**CONTINUING ELIGIBILITY INSPECTION (CEI) REPORT FOR
FLOOD CONTROL WORKS (FEDERAL)**

1. Project Name: Namu River Flood Control Project
2. Date of Inspection: March 25, 2004
3. Inspection Personnel:

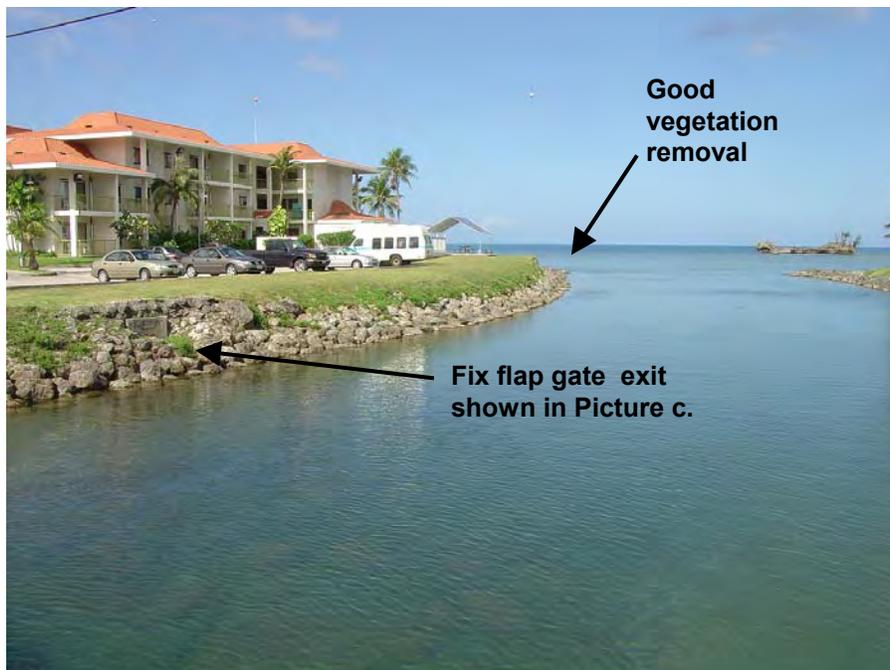
a. Sta. 3+90 to 0+00, RB looking d/s from Marine Drive, very good vegetation removal, occasional coconut needs to be removed

b. Sta. 3+90 to 0+00, LB looking d/s from Marine Drive, good vegetation removal, fix flap gate, as shown in c.

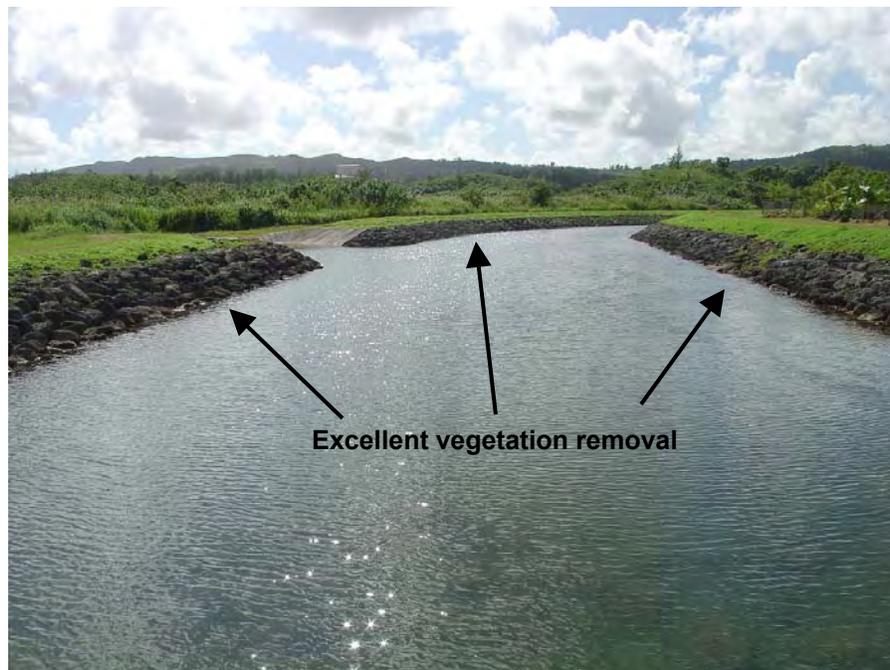
- c. Sta. 3+20 (approx), Clear rocks and debris so flap gate exit is clear and can work properly, grease flap gate hinges, LB d/s from Marine Drive

- d. Sta. 3+90 (approx), RB d/s at Marine Drive, typical case where coconut tree needs to be removed

View of Drop Structure

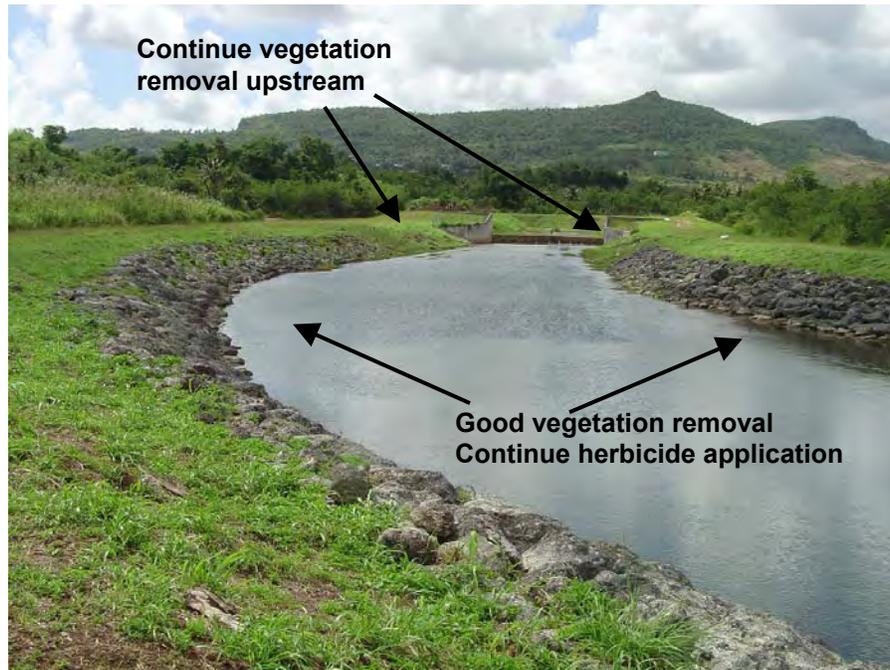
g. Sta. 7+55 (approx), looking upstream from RB, good vegetation removal, need to continue vegetation removal upstream, continue herbicide application to control vegetation throughout

h. Sta. 12+00 (approx), View of drop structure that has good flow through it, remove vegetation and material from banks so riprap is visible
